# Dewberry Response to USGS Review of the Texas Neches Lidar Project

Produced for U.S. Geological Survey

USGS Contract: G16PC00020

Report Date: 4/03/2018

Figure 2 - Tile 15RVP4023345-- This waterbody does not meet -collection requirements as a portion of the feature is dry at the time of acquisition and the “wet” portion is less than 2 acres in size. This waterbody was not collected for consistency purposes.

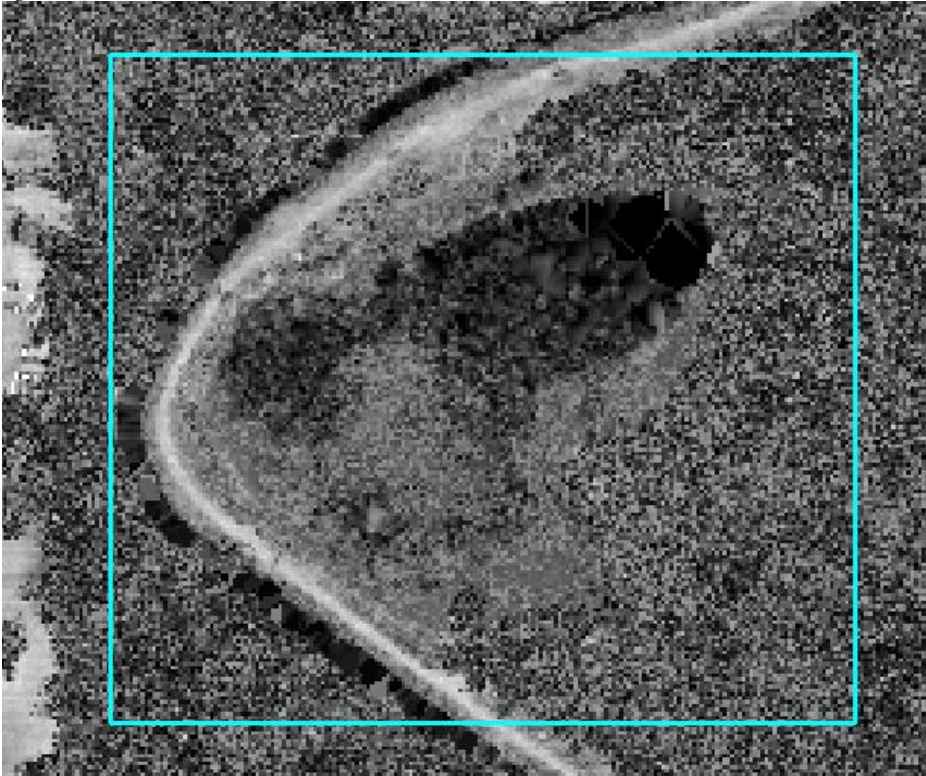
USGS placed two hundred thirty three (233) hydro calls to hydro-flatten features meeting minimum collection requirements. Two hundred twenty two (222) of the calls were corrected. Upon review, Dewberry determined that eleven (11) features requested to be hydro-flattened were not waterbodies by definition or should not be collected for consistency proposes. Examples are shown below.

Figure 6 | ~~15RTR2385220xxx~~ Most hydro calls identifying features for hydro-flattening have been corrected. This feature is greater than 2 acres in size-breaklines have been updated, LAS hydro-classified, and the DEM hydro-flattened.

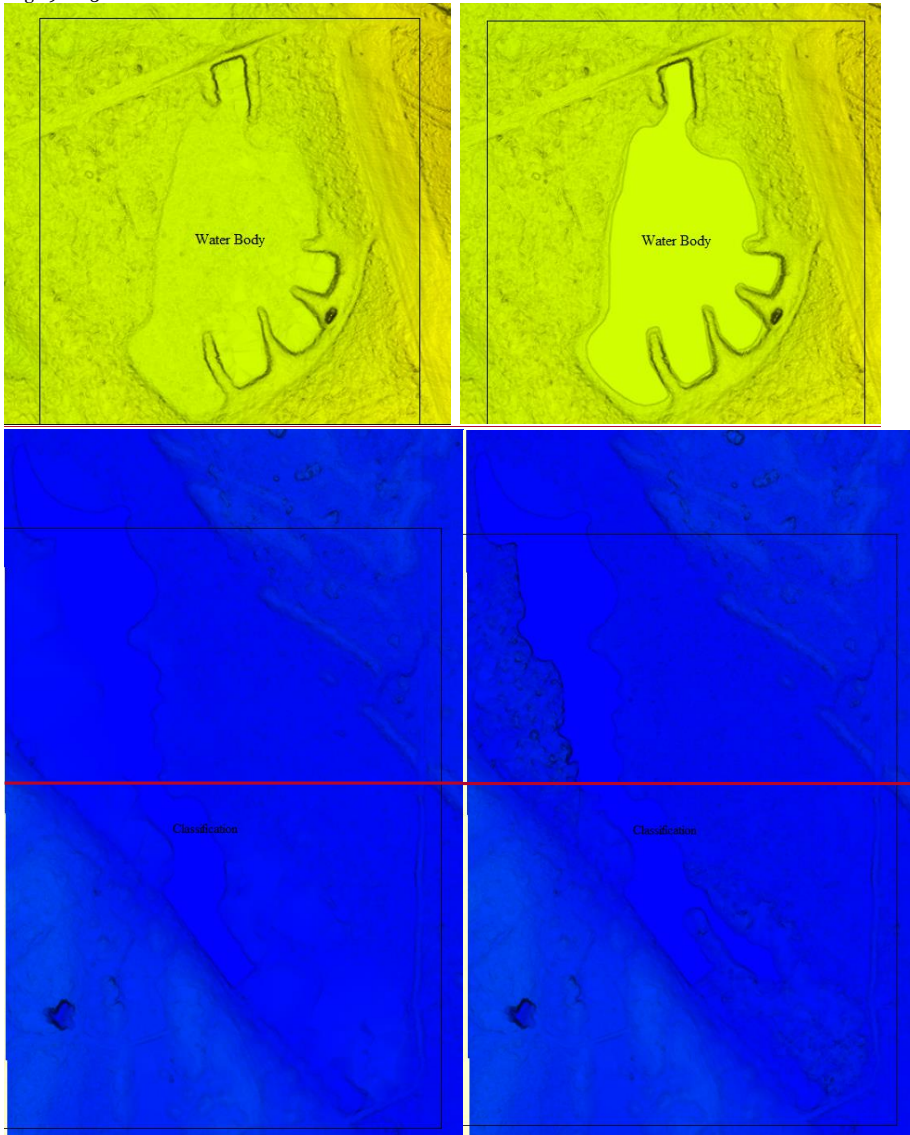
**Commented [NJ1]:** Add an example of an edit call we did fix. Show original on left and corrected DEM on right.

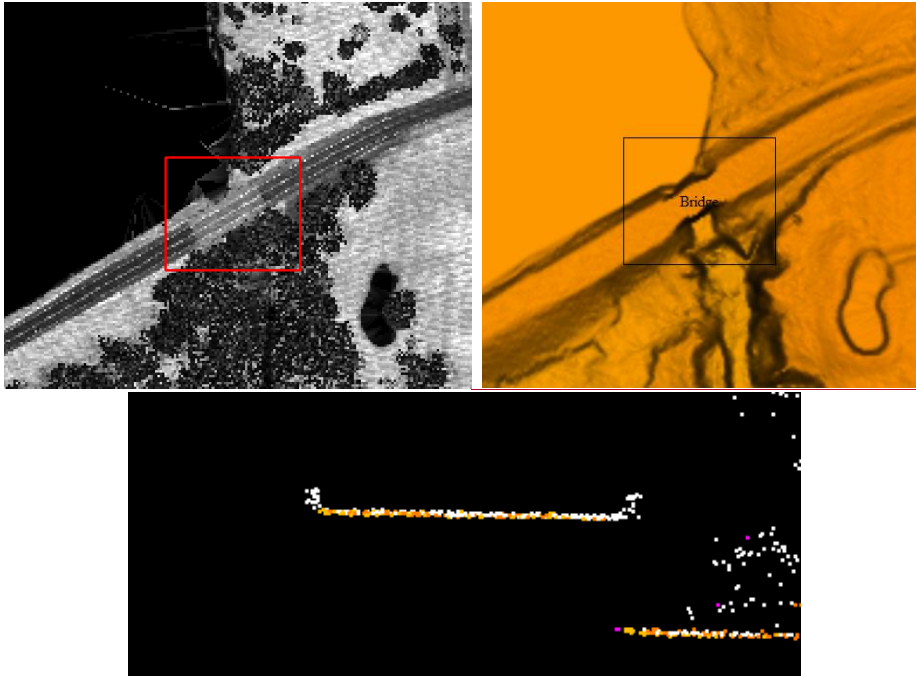
USGS made sixty-four (64) DEM/Classified LAS calls. Sixty-one (61) of the calls were corrected. One (1) call was to remove a bridge which was actually a box culvert and should remain in ground. Two (2) calls were to remove dams. The dam structures have been left classified in the ground class since they are acting as impoundments. Examples are shown below.

**Commented [NJ2]:** Either show the intensity side by side with the DEM or side by side with a lidar profile to show the culvert remains classified as ground.

**Figure 6 - 15STR2375685—Box culvert should remain in ground class. The left image shows the box culvert in the intensity imagery. The right image shows the box culvert remaining in the bare earth DEM. The bottom image is a profile of the box culvert. Ground=orange, white=unclassified, pink=low point)**

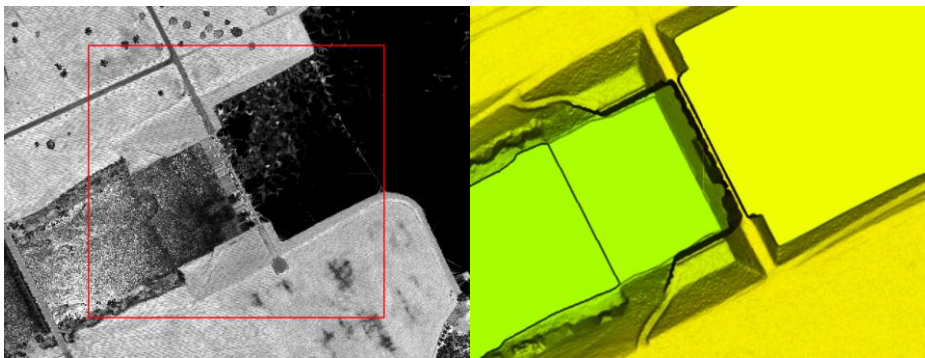
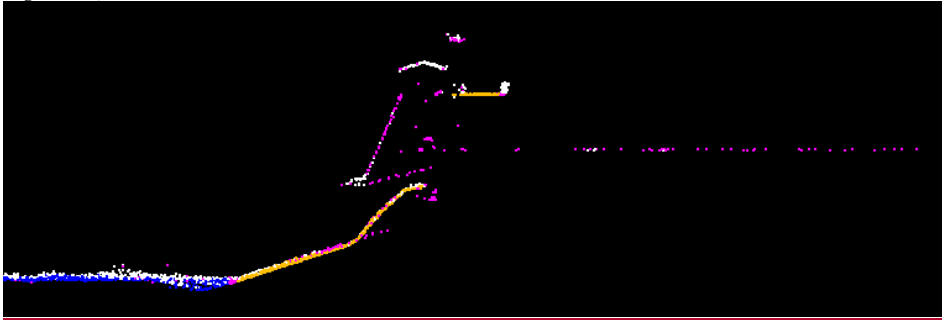
**Commented [NJ3]:** Show the DEM and a lidar profile here as well to fully represent the dam and show how it's being modeled. This will also show the water at two very different levels and how the dam is an impoundment.

Figure 7 - 14SQA2045700 and 14SQA2025700—Dam is acting as an impoundment and should remain in ground. **The left image shows the dam in the intensity imagery. The right image shows the dam remaining in the bare earth DEM. The bottom image is a profile of the dam acting as in impoundment. Ground=orange, white=unclassified, pink=low point)**

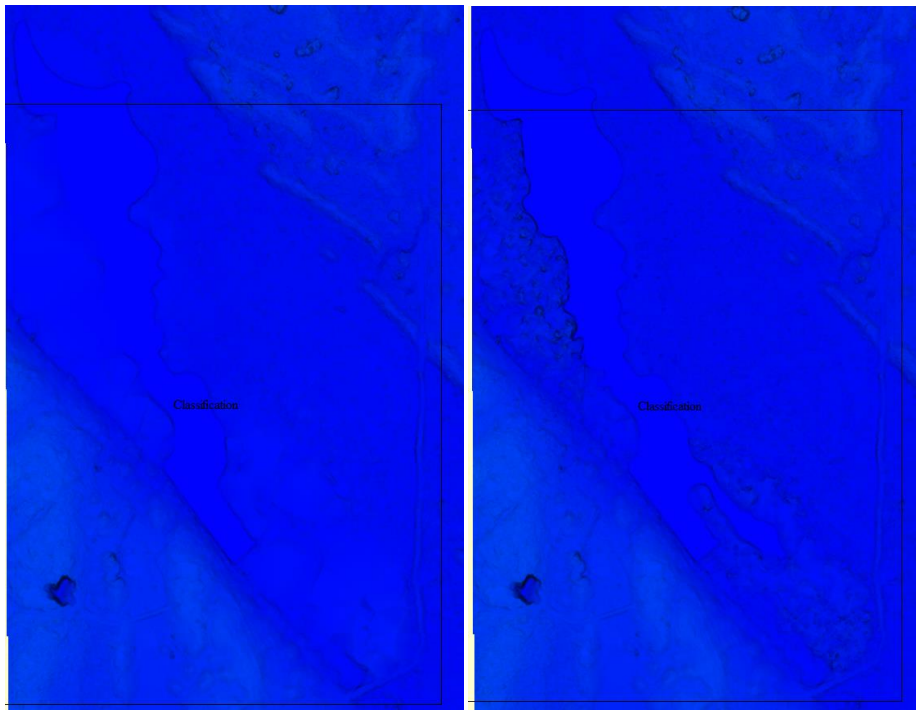
**Commented [NJ4]:** Add an example of an edit call we did fix. Show original on left and corrected DEM on right.

Figure 8 - 15RUP3313450 and 15RUP3303450xxx—Most of the DEM/Classified LAS calls have been corrected. In this example, **USGS made a classification call for tinning around a waterbody. Dewberry added ground points around the waterbody and adjusted the breaklines to get a more accurate representation of the bare earth surface.**
